**FINAL ENGINEERING PLANS  
FOR  
SUMMIT HOUSING GROUP - PUBLIC IMPROVEMENTS**

LYONS VALLEY PARK FILING NO. 8

**COVER SHEET  
SUMMIT HOUSING GROUP  
LYONS VALLEY PARK FILING NO. 8  
LYONS, COLORADO**

**GENERAL NOTES**

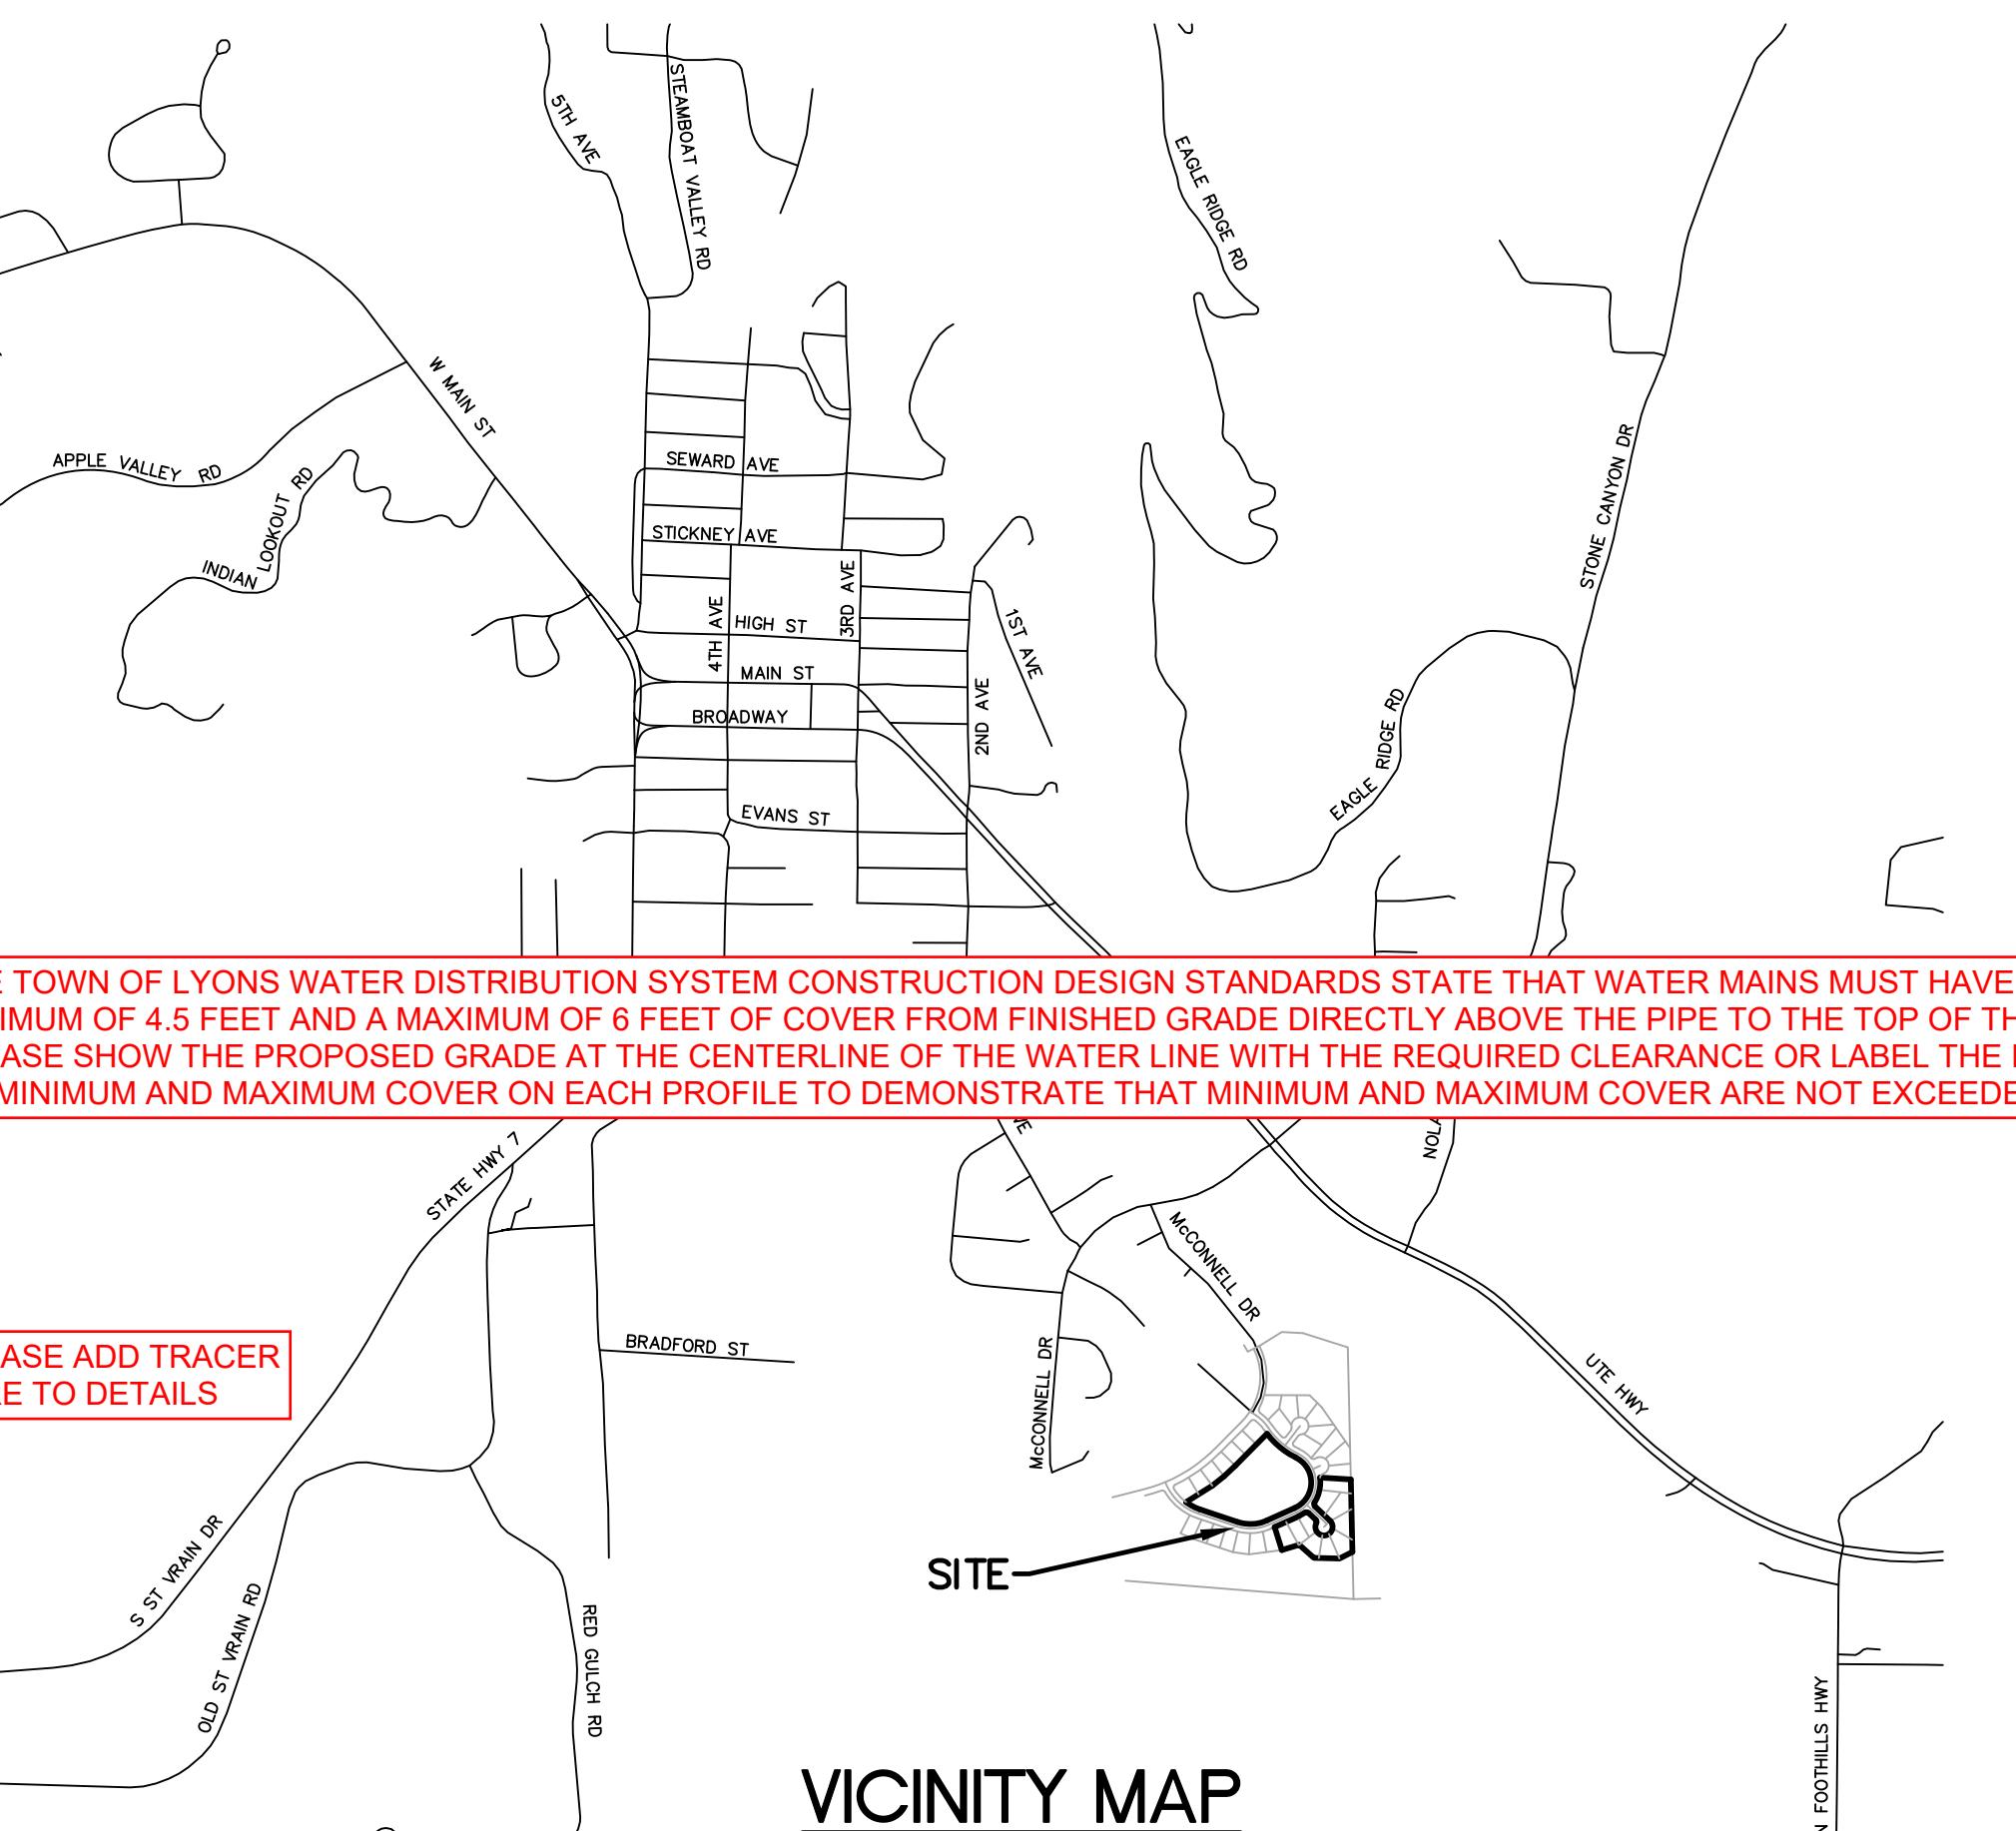
**ADD THE FOLLOWING NOTE:**

FOR PVC PIPE, THE CURVATURE OF THE PIPE SHALL BE ACCOMPLISHED THROUGH LONGITUDINAL BENDING OF THE PIPE BARREL. DEFLECTION OF THE JOINT IS NOT ALLOWED AND MAY CAUSE LEAKAGE. CONFIRM THE MINIMUM RADIUS IS MET PER MANUFACTURER'S REQUIREMENTS.

Please provide documentation on how the water quality capture volume is being achieved; how water quality treatment standards and requirements from CDHDE and/or MHFD (UDFCD) are being met utilizing the existing porous landscape detention area. This water quality/detention facility that was designed and documented in a drainage report 13 years ago, please confirm that the water quality BMPs using current MHFD standards are being met.

**ADD APPROVAL BLOCK**

**ADD SIGNATURE (TYP.)**

**LEGEND**

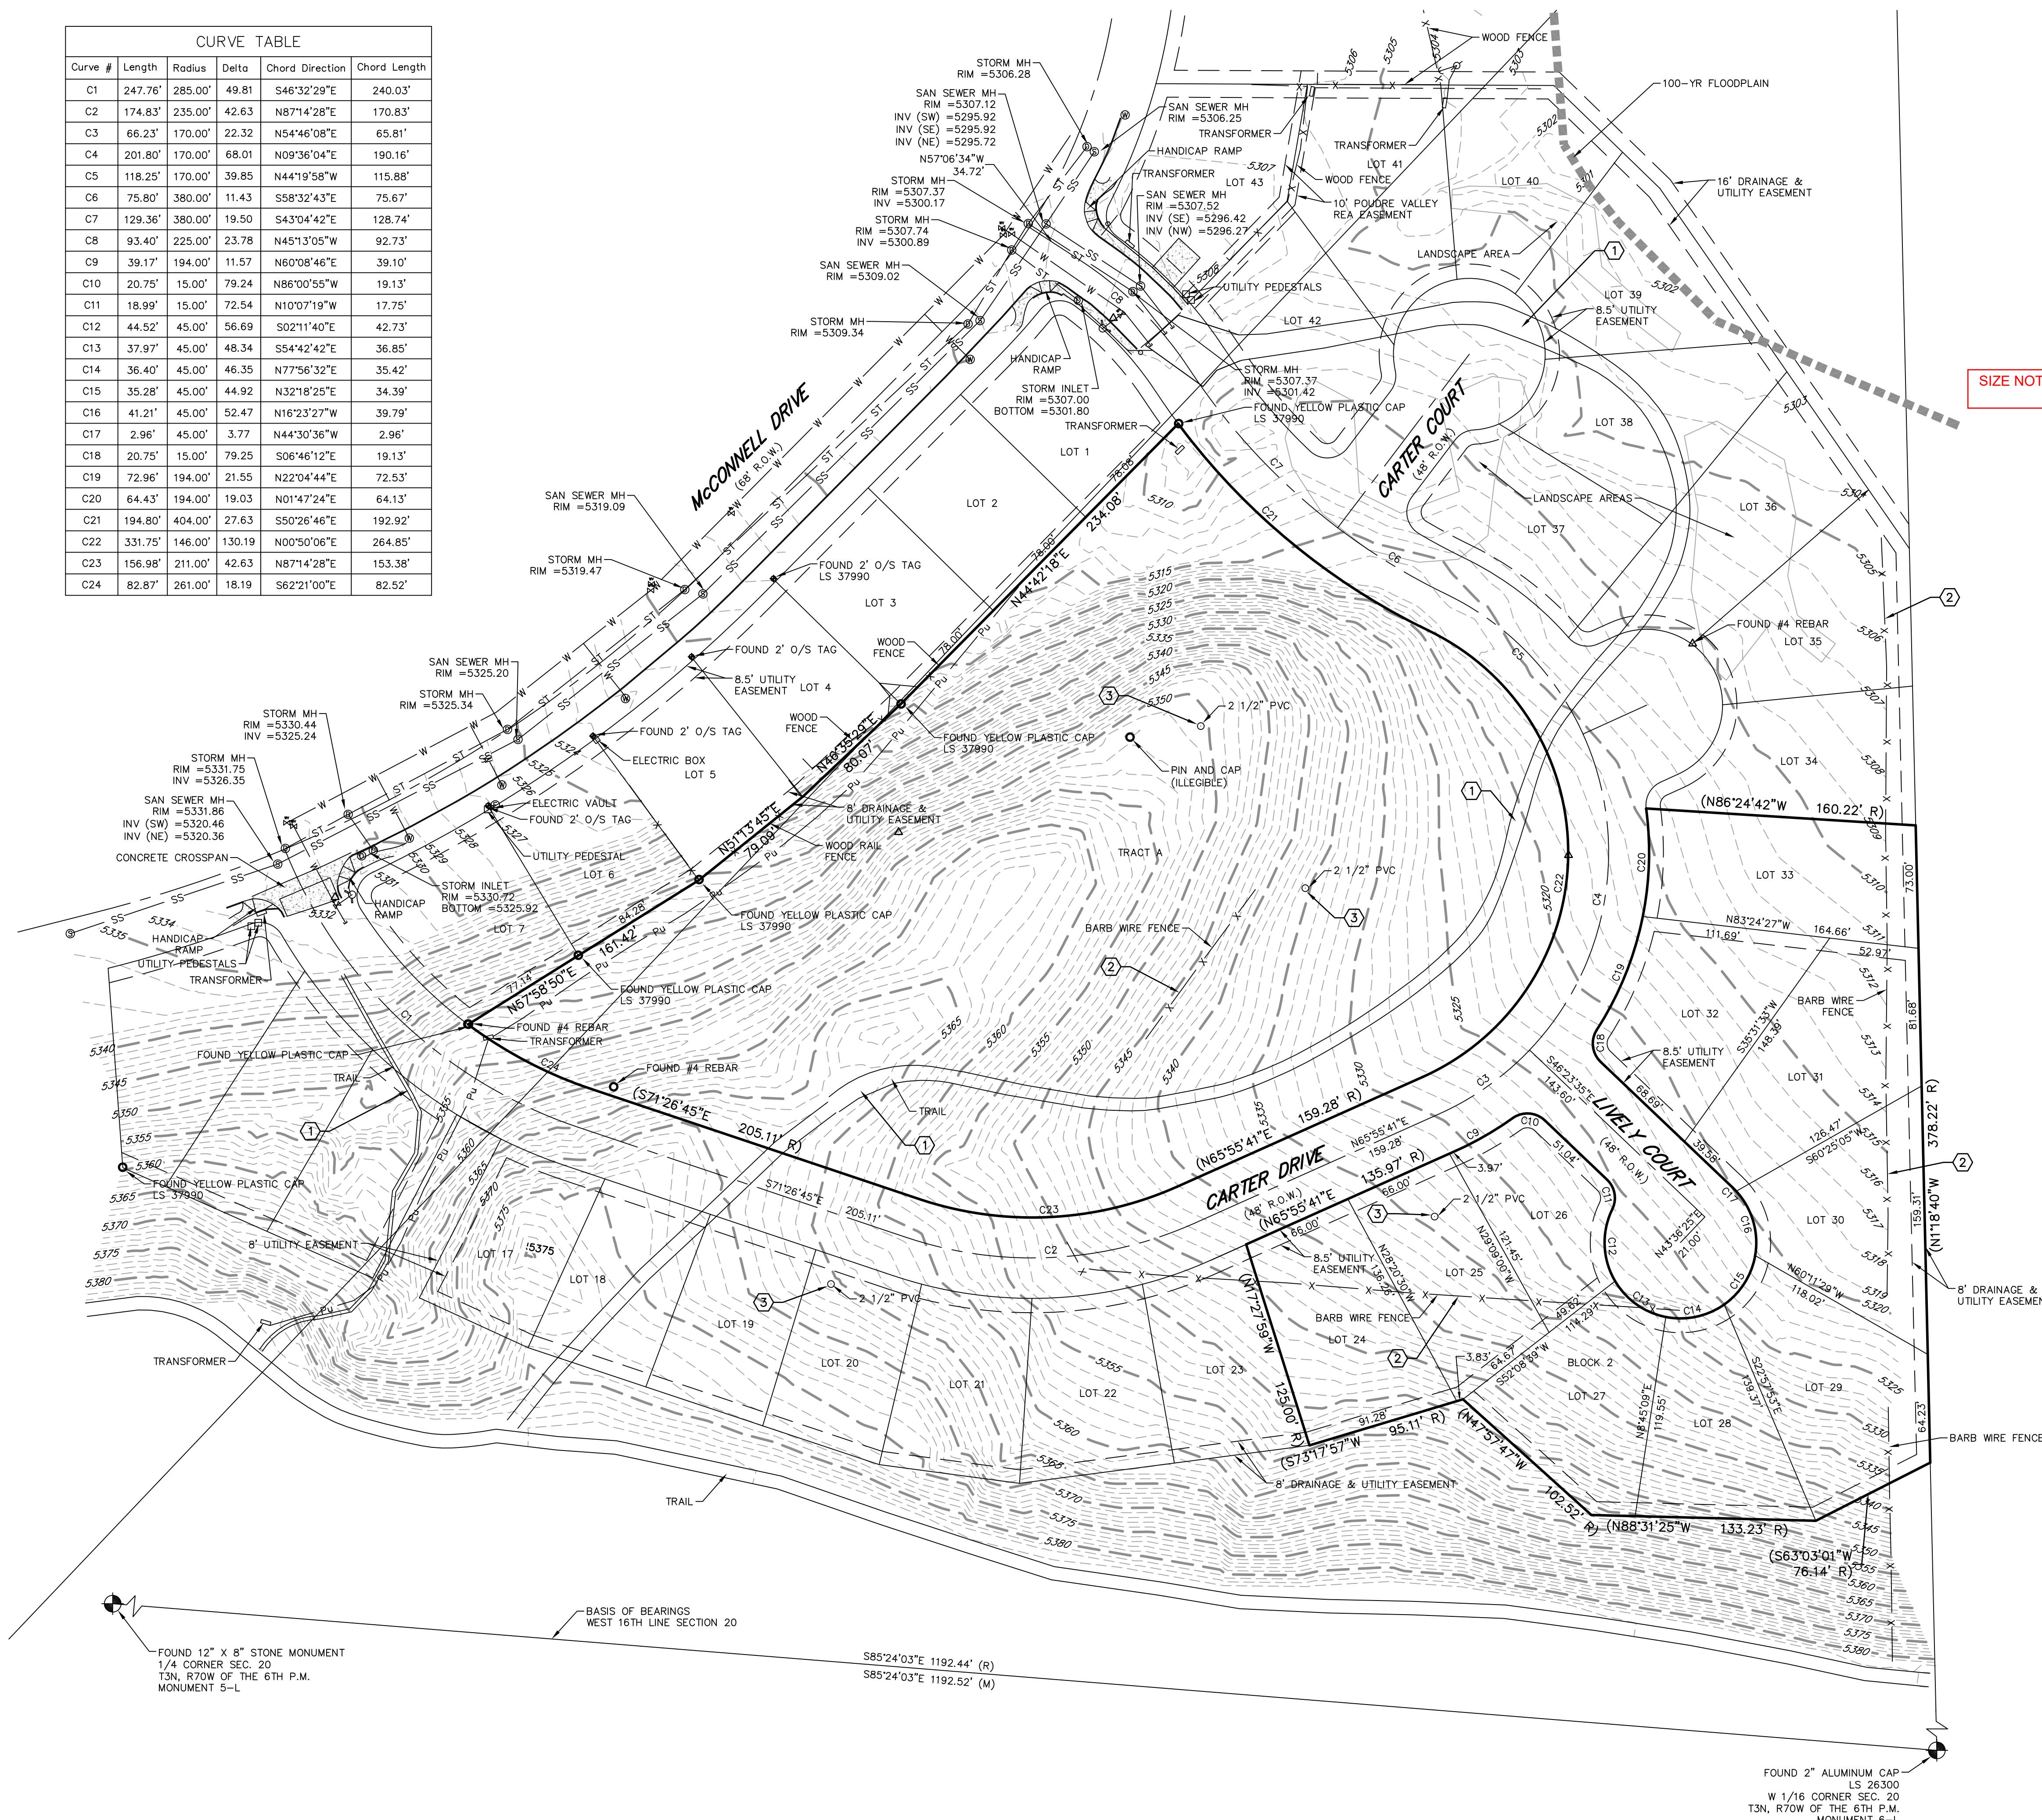
**ADD/DEFINE THE FOLLOWING SYMBOLS:**

**CIVIL SITE PLAN  
SUMMIT HOUSING GROUP  
NS VALLEY PARK FILING NO. 8  
LYONS, COLORADO**

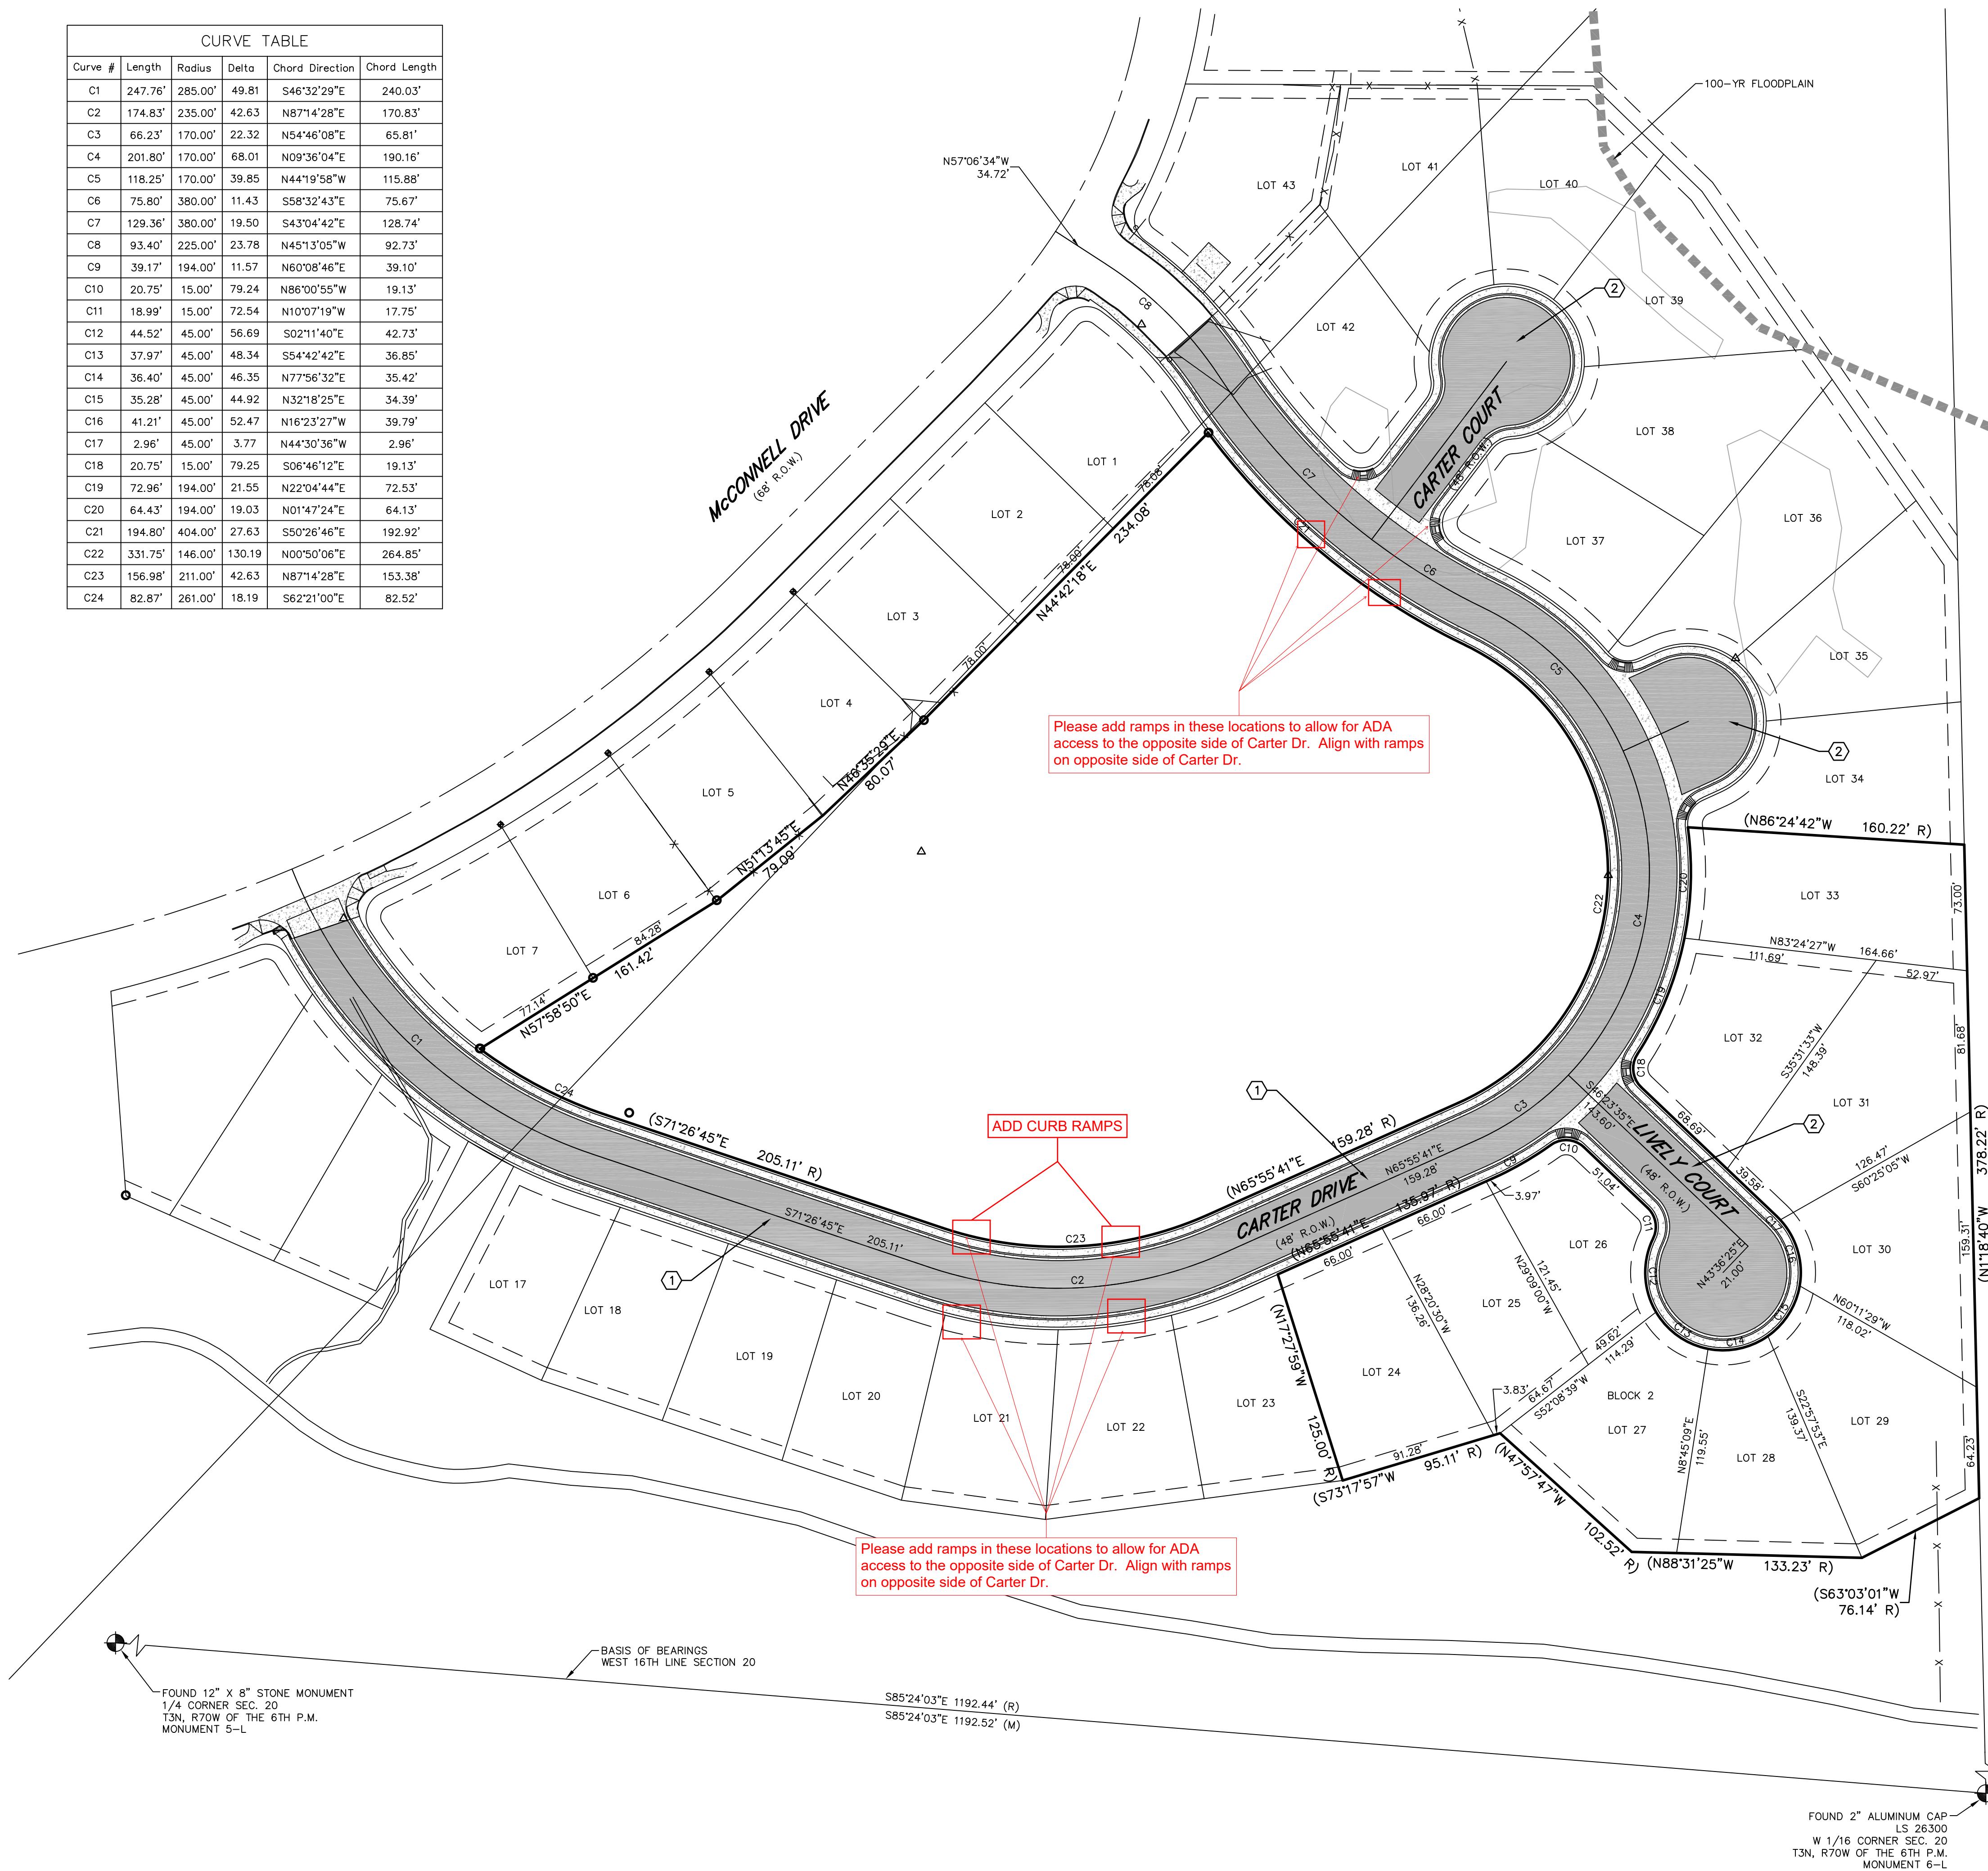
## DEFINE ROADWAY HATCHING

Please add ramps in these locations to allow for ADA access to the opposite side of Carter Dr. Align with ramp on opposite side of Carter Dr.
